# Japanese position about MRM-LC

#8 ALKS-SIG  
September, 2021  
Japan

# Current Options for MRM LC

# Accidental data

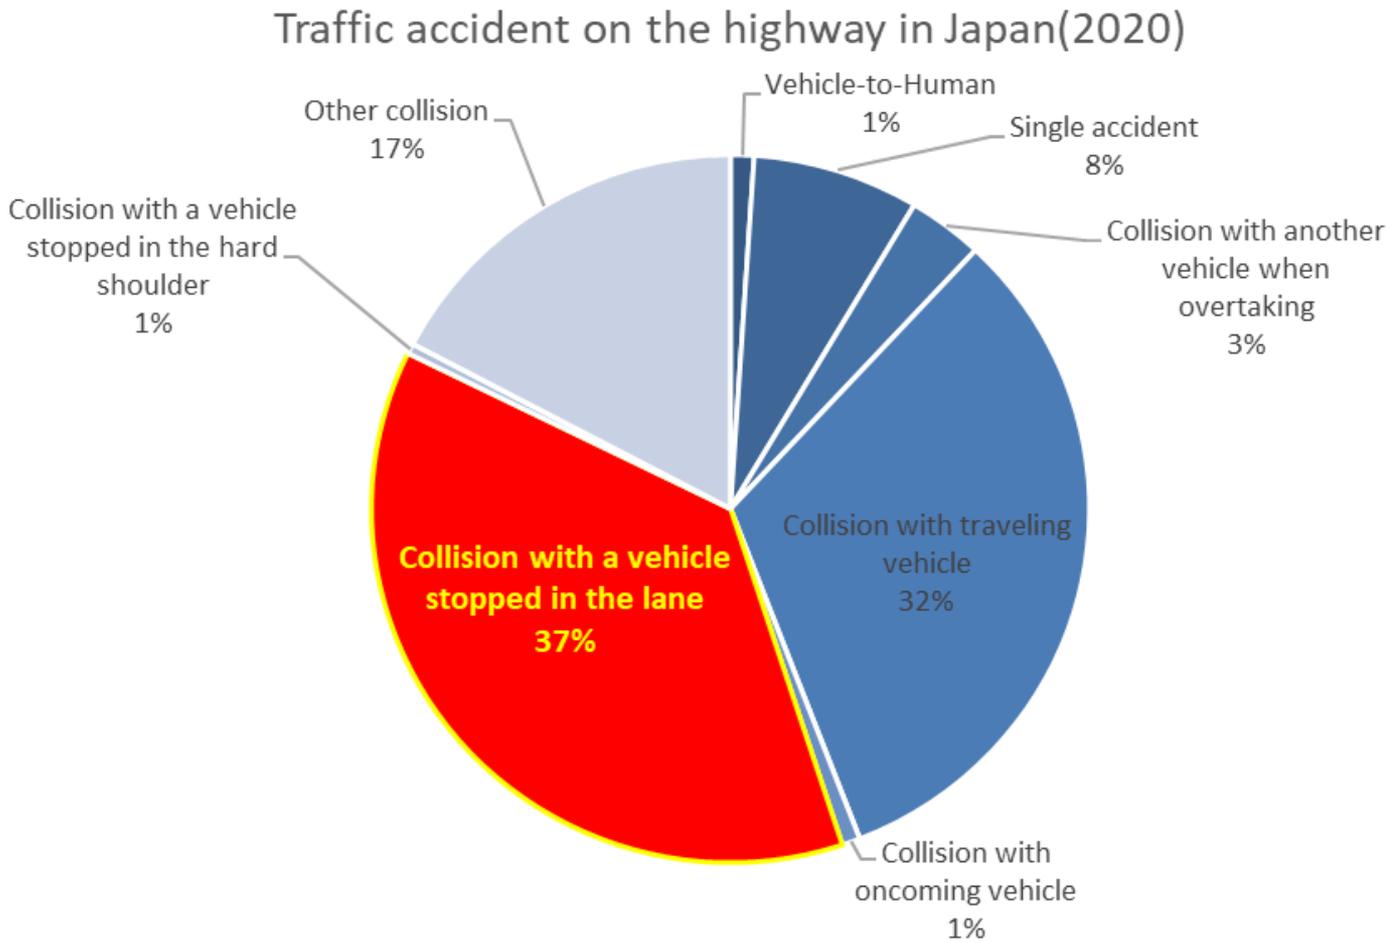
There are big safety concern about stopping in lane. Actually, there are a lot of accidents in such case, see following slide.

That should not be the reason why ADS dose not need to have MRM-LC. We should try to reduce such dangerous situation.

According to our accidental data, about 40% of all highway accidents (total: 4649 accidents) is collision with a vehicle stopping in the lane. Therefore, we try to avoid such situation that ADS stops in its lane for avoiding accidents.
